CHESAPEAKE SUBDIVISION, **UNIT 1 & UNIT 2**

APPLICATION NUMBER 15 DATE June 6, 2013
APPLICANT Chesapeake Subdivision, Unit 1 & Unit 2
REQUEST Subdivision

DETAIL SITE PLAN

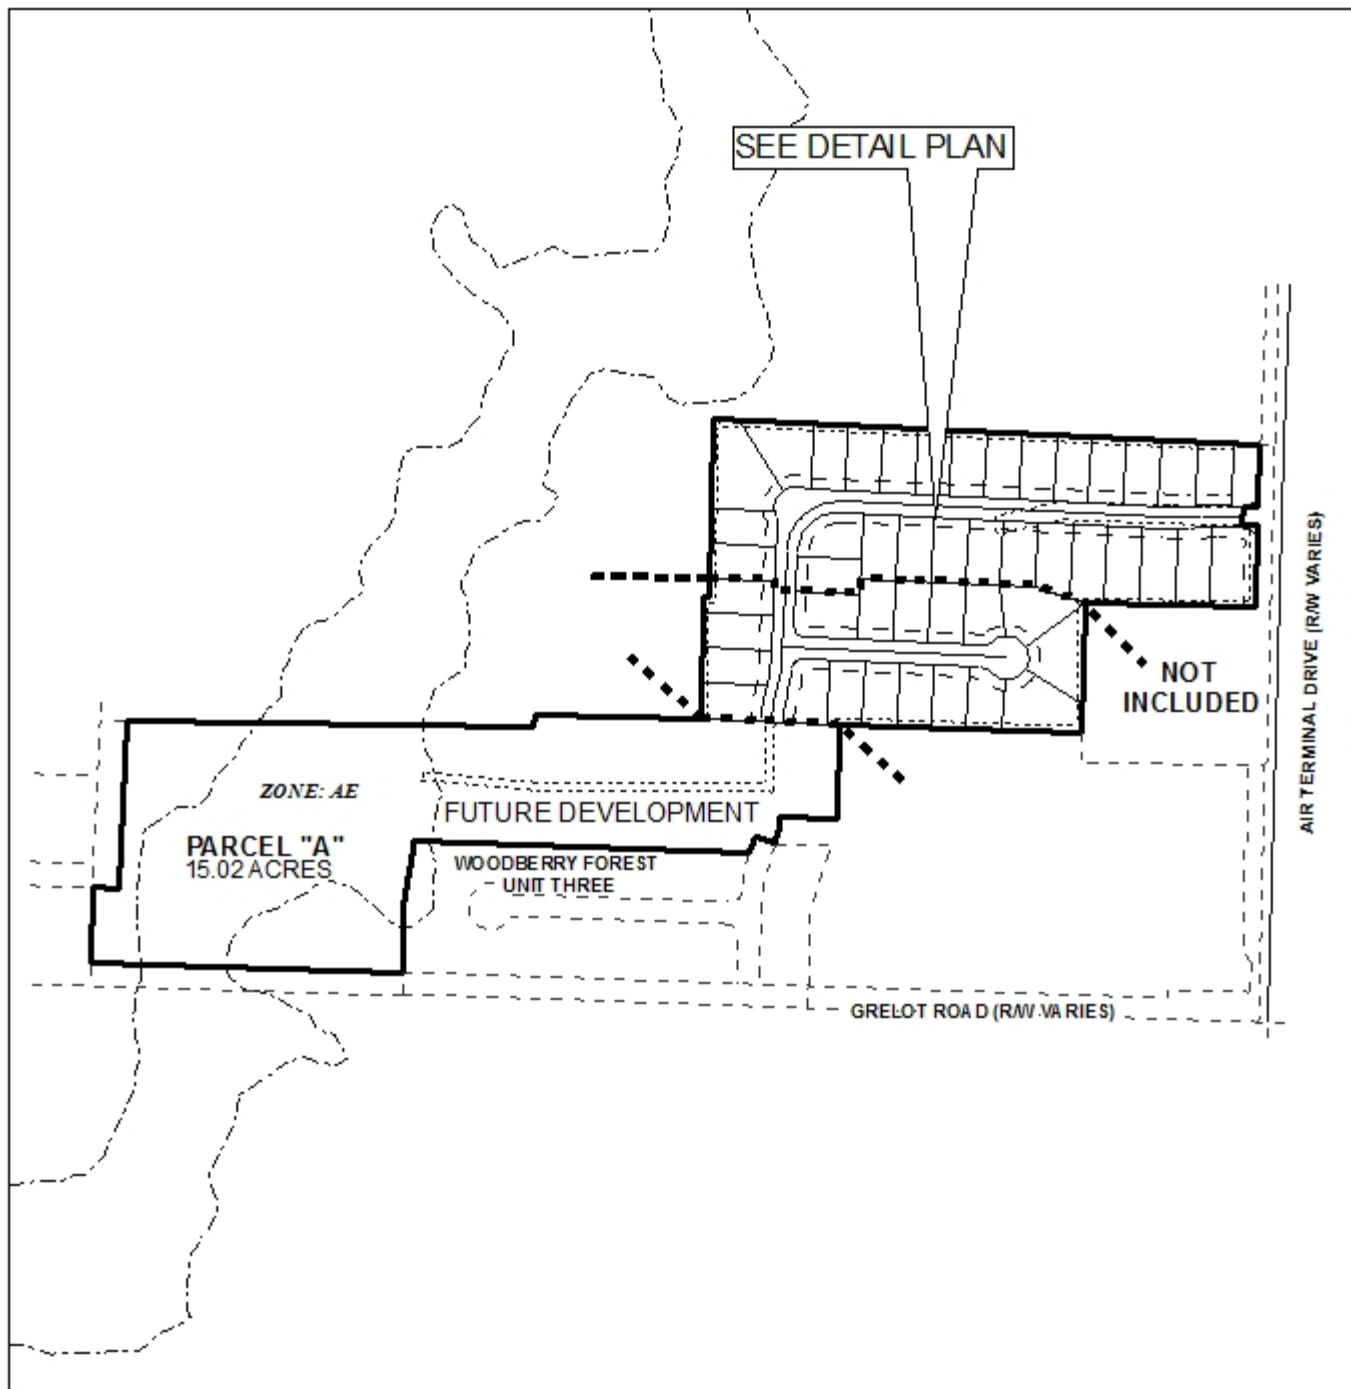
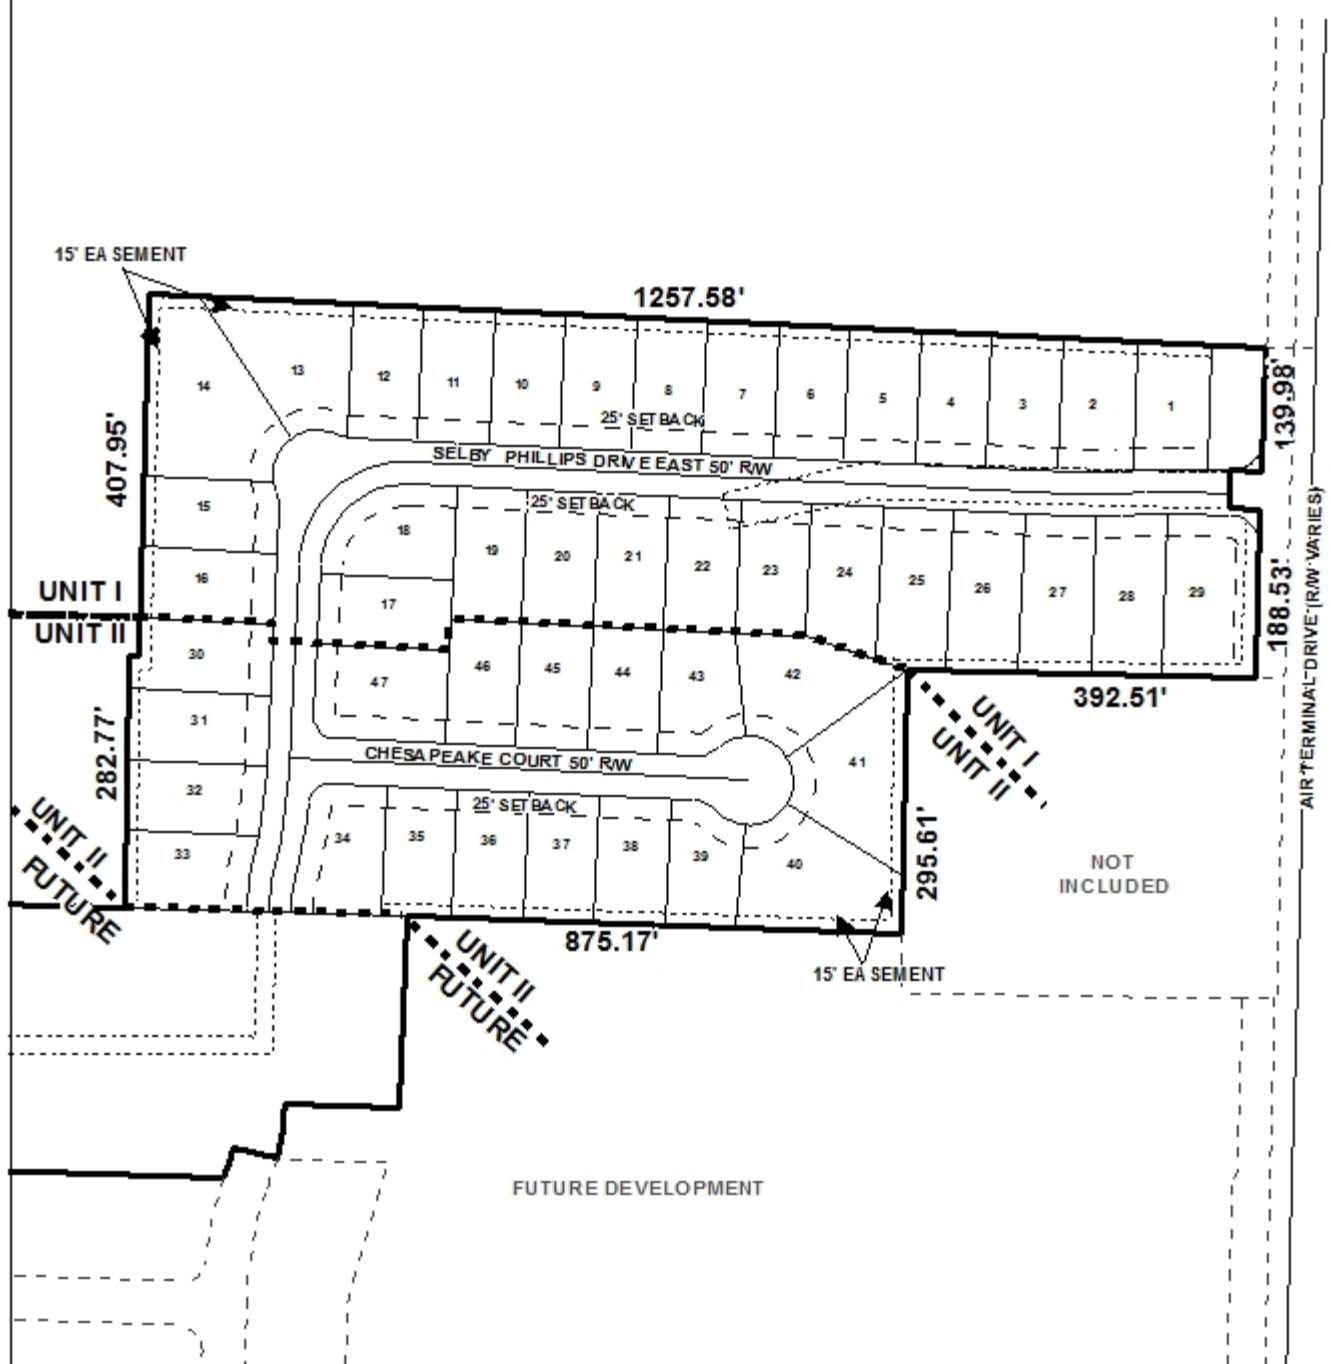
The site fronts Air Terminal Drive, a proposed major street with an existing variable right-of-way as illustrated on the preliminary plat. However, this is required due to the 100-foot right-of-way width requirement for major streets, if in the future the road widened.

Development of the site will require the construction of new streets. The development will access Air Terminal Drive via one street, with a street stub to the "Future Development". Two cul-de-sacs are proposed within the development, and the plat indicates that the cul-de-sac diameter does not comply with the requirements (120-feet) of the Subdivision Regulations. Therefore, the Final Plat should illustrate compliant cul-de-sac right-of-way to comply with All roads must be paved in asphalt or concrete, built to County standards, and accepted by the County prior to the recording of the Final Plat.

It should be noted that the site abuts an undeveloped "Future Development" area. Section V.B.14. of the Subdivision Regulations require the provision of street-stubs to adjacent

properties; therefore, the plat should be revised to depict an acceptable turn around to provide access by emergency vehicles upon completion of each Unit.

As designed, Lot 29 will have frontage onto an internal street to the proposed subdivision as well as frontage onto Air Terminal Drive. To minimize the number of curb-cuts onto Air Terminal Drive, Lot 29 should be denied direct access to Air Terminal Drive. All lots within the development should be limited to one curb-cut, with the size, design and location to be approved by Mobile County Engineering, and to comply with AASHTO standards.

Detention/common areas are proposed for the subdivision. Therefore, all common areas should be labeled, and a note should be placed on the Final Plat, if approved, stating that maintenance of the detention/common areas, are the responsibility of the subdivision's property owners.

- 1) revision of the plat to illustrate dedication to provide 50-feet from the centerline on Air Terminal Drive;
- 2) construction and acceptance by Mobile County Engineering of all streets;
- 3) revision of the preliminary plat to illustrate acceptable turnarounds at completion of Units 1 and 2;
- 4) placement of a note on the Final Plat labeling all detention facilities and common area, stating that maintenance of the detention/common areas, are the responsibility of the subdivision's property owners;

- 5) placement of a note on the Final Plat limiting each lot to one curb cut each, with the size, design, and location of the curb cut to be approved by Traffic Engineering and conform to AASHTO standards;

- 6) placement of a note on the Final Plat stating that Lot 29 is denied direct access to Air Terminal Drive;
- 7) placement of a note to comply with the City of Mobile storm water and flood control ordinances (*Must comply with the Mobile County Flood Damage Prevention Ordinance. Development shall be designed to comply with the storm water detention and drainage facility requirements of the City of Mobile storm water and flood control ordinances, and requiring submission of certification from a licensed engineer certifying that the design complies with the storm water detention and drainage facility requirements of the City of Mobile storm water and flood control ordinances prior to the issuance of any permits.*); and
